Product Change Notification

PCN-PCC-8501-2023

Business Unit	Product Line Code	Type of Change	Action	Date of Issue
PCC - PCB Connectors	AAC	Product Change Notification	Notify Distributors and Field	1/30/2023

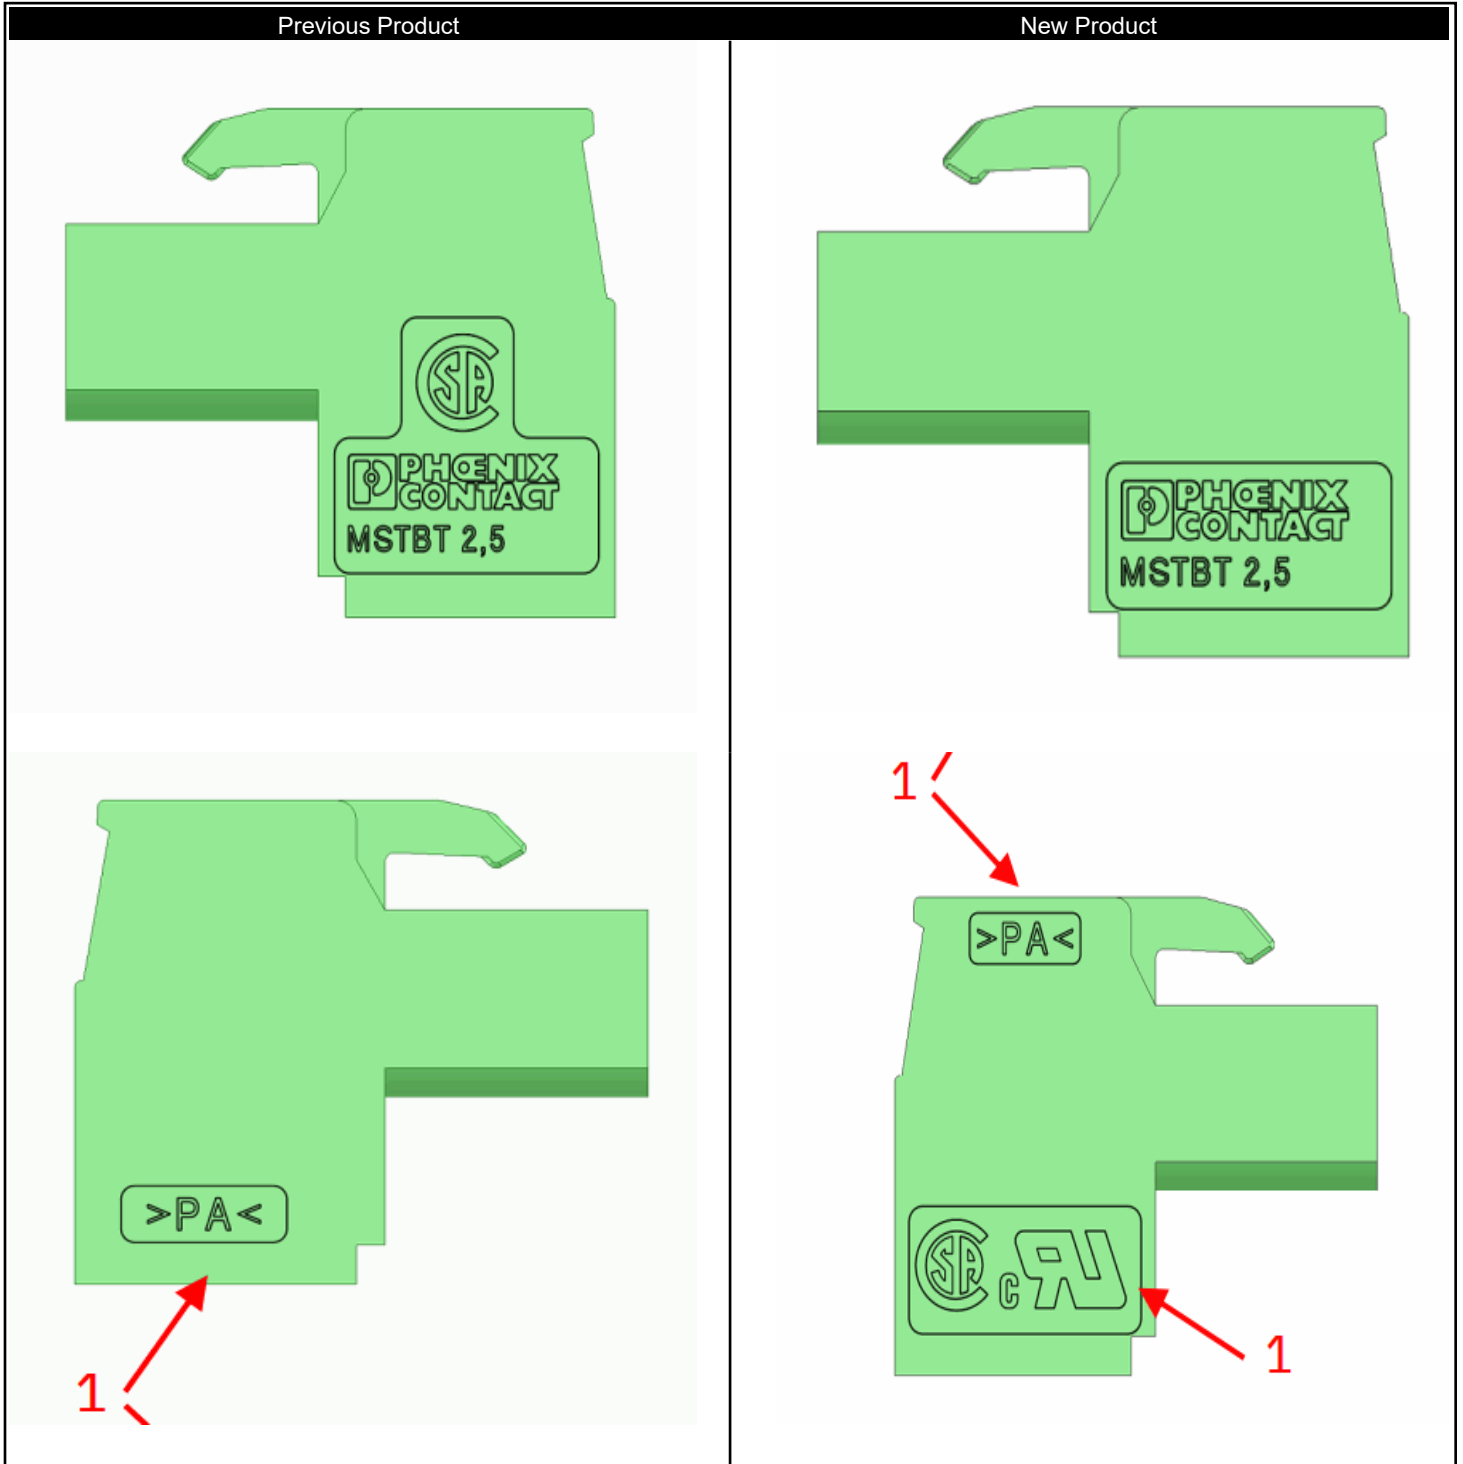
Description for Product Change Notification
As part of the creation of new injection molds for 2- to 8-pos., the labeling fields (1) will be updated. In addition, the screw flange versions will take on the housing contour (2) of the standard MSTB 2.5/..-STF connector. The external dimensions and technical data will not change. The batch number will not be raised. Visual old vs. new comparisons are available in the appendix.
